Carlson Software Expands Carlson College

How Does Carlson Support Their Users? Ask David Farina

Here is the original question from David Farina on March 4, 2009:

Time of Concentration (TR-55)

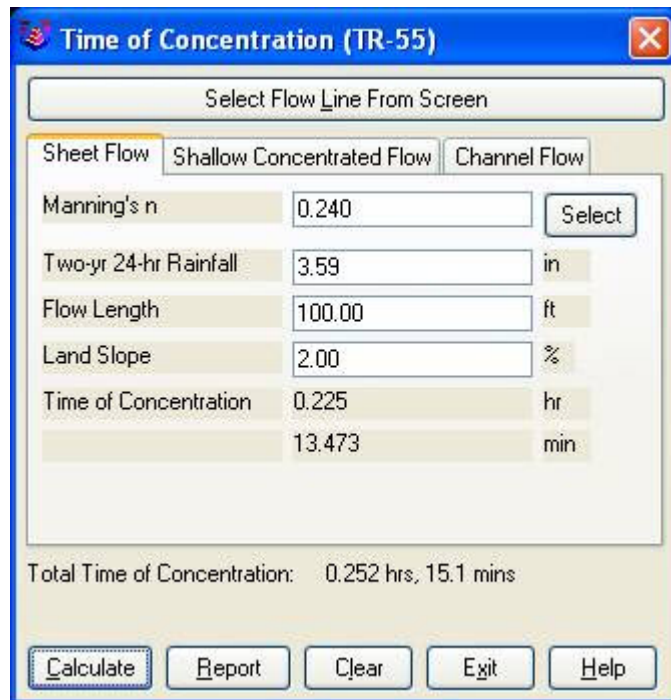
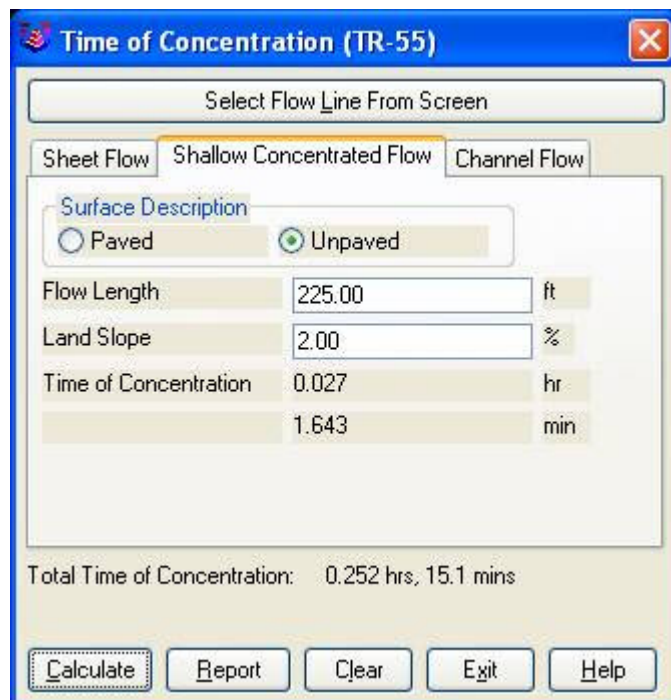
I was going through a mock project to learn the hydrology part of Carlson and noticed a critical deficiency in Time of Concentration input. The review agencies around here want to see the TR-55 method. First, the TR 55 minimum sheet flow needs to be 100' instead of 300'. They recently changed it per the TR-55 Web site. Second, I don't think I've ever had a project where you didn't have to split one of these flow types into 2 or more mannings roughness areas.

For example: a flow path that starts on dense grass for 50' then passes over asphalt for 75' and back to grass for 200' would need to be calculated as follows:

Sheet flow 50' Grass -> Sheet flow 50' Asphalt -> Shallow Concentrated flow 25' Paved -> Shallow Concentrated flow 200' UnPaved.

But as you can see the Carlson input only allows for one entry

per flow type.

Here's an update to the Tc by TR-55 routine that allows

unlimited number of breakouts. This update is for Carlson 2009 on Acad 2007-09. To install, unzip and copy the arx to the Carlson2009LSP folder. Let me know if you need a different version or have more suggestions.

Time of Concentration (SCS)

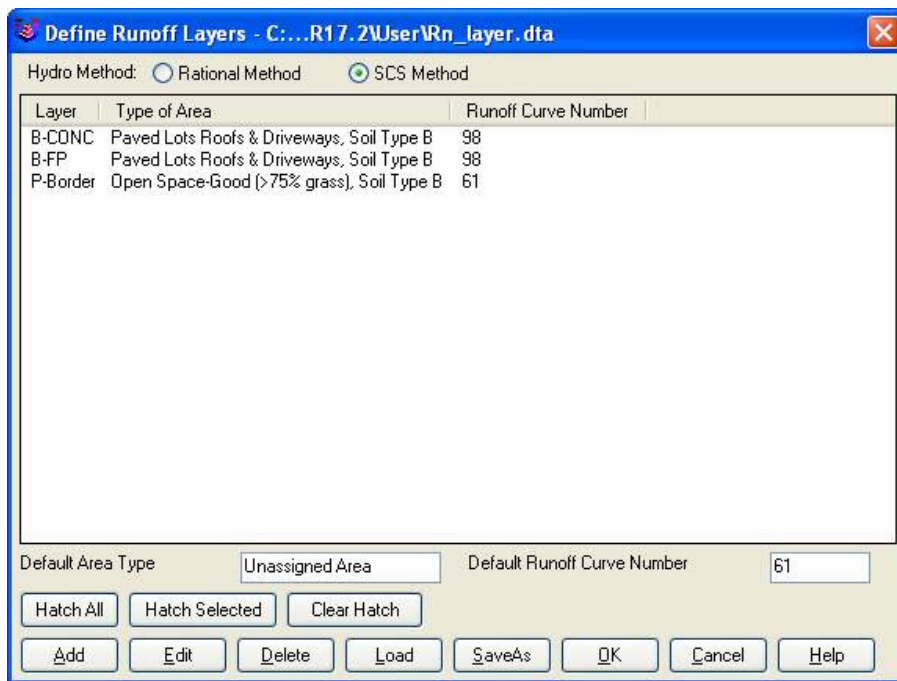
Was the SCS method used to get the 7.1 min value?

Notice the 7.5 value in the TC dialog to the right.

This was the value if I SELECT FLOW LINE FROM SCREEN and pick the path that the dialog on the left generates.

Can I generate a report of how the time to inlet was calculated?

Maybe there can be a button next to the Time to inlet to select TR-55

Maybe Mannings coefficients can also be put into the WATERSHED->DEFINE RUNOFF LAYERS to be used for this calc as the flow path passes through each polyline area the same way Carlson already calculates the composite CN.

For the Storm Sewer Network routine, I put it on the to-do list to add a Select button next to the Tc to show the components that make up the Tc like the Select button does for CN. Also we will look at adding Manning's n to the Define Runoff Layers for use with Tc calcs.
